## Change Order, Construction Manager as Adviser Edition

Christian County High School

Change Order Number: 093

<b>Project:</b>	Christian County High School 5185 Ft. Campbell Blvd Hopkinsville, KY 42240	<b>PR No.:</b>	061
		<b>Date:</b>	September 2, 2025
<b>Owner:</b>	Christian County Public Schools 222 Glass Ave Hopkinsville, KY 42240	<b>Project Number:</b>	2106-204
		<b>Contract for:</b>	116 – Gym Equipment 260 - Electrical
<b>To:</b>	Kevin Hitchell Alliance Corporation 116 E. College Steet Glasgow, KY 42141		
<b>RE:</b>	<b>Main Gym Scoreboard</b>

- **Four-Sided Full Color LED True Pixel Video Display**  
6.56'H x 8.20'W 3.9mm (512 x ? pixel matrix)
- **Custom Imprinted Wedge Panel (4)**
- **Custom Imprinted Bottom**

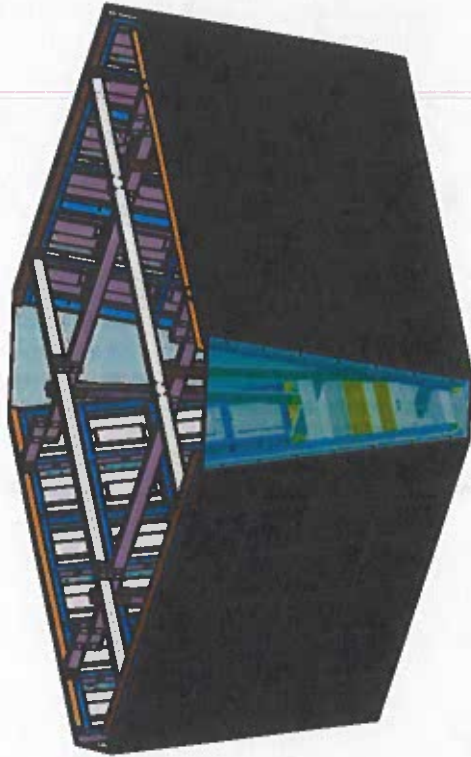
- 1) Provide four-sided video scoreboard Nevco 69886B in lieu of originally specified scoreboard. Include corner piece and underside graphics in bid in main gymnasium.
- 2) Provide all accessories and supports and misc. materials as req'd to hang scoreboard from structure.
- 3) Provide all controls, wiring and accessories to provide a fully operational scoreboard.

Pekin High School  
 Pekin, IL 4-Face  
 3.9mm Video Display  
 Electrical Installation

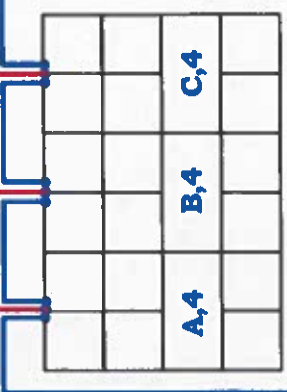
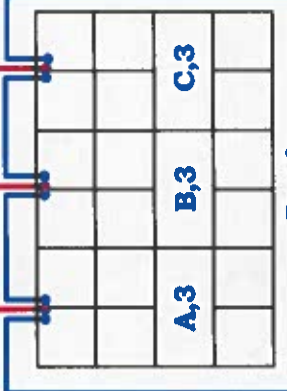
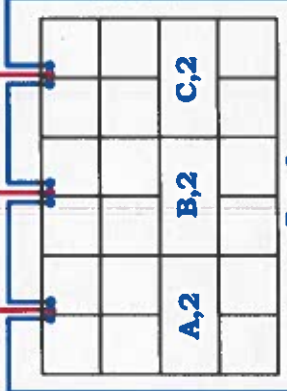
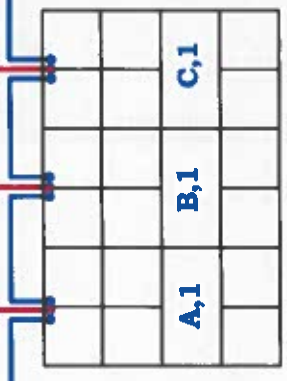
- 4) In lieu of the quantity one 20A, 120V single-phase circuit to the score board, provide a quantity of two 20A, 208Y/120V circuits to the video score board. Terminate the two circuits each within a L21-20R receptacle at the video score board per equipment provider's requirements.
- 5) The "C2" data outlet as shown on the original Contract Drawing E3.2B-Alt shall remain and be installed within the new video scoreboard for an owner-furnished and installed wireless access device.
- 6) Provide two 1" conduit raceways from the video scoreboard to the Area B data room B191. The video scoreboard provider will furnish and install eight ethernet cables (four within each

conduit) from a scoreboard video controller within data room B191. (See attached sample electrical installation for Pekin High School) for additional information regarding the NEVCO video scoreboard system.

**Requires (2) Branch Circuits**  
**Use high inrush current circuit breakers for video displays.**

L21-20R Receptacle  
 (By Others)
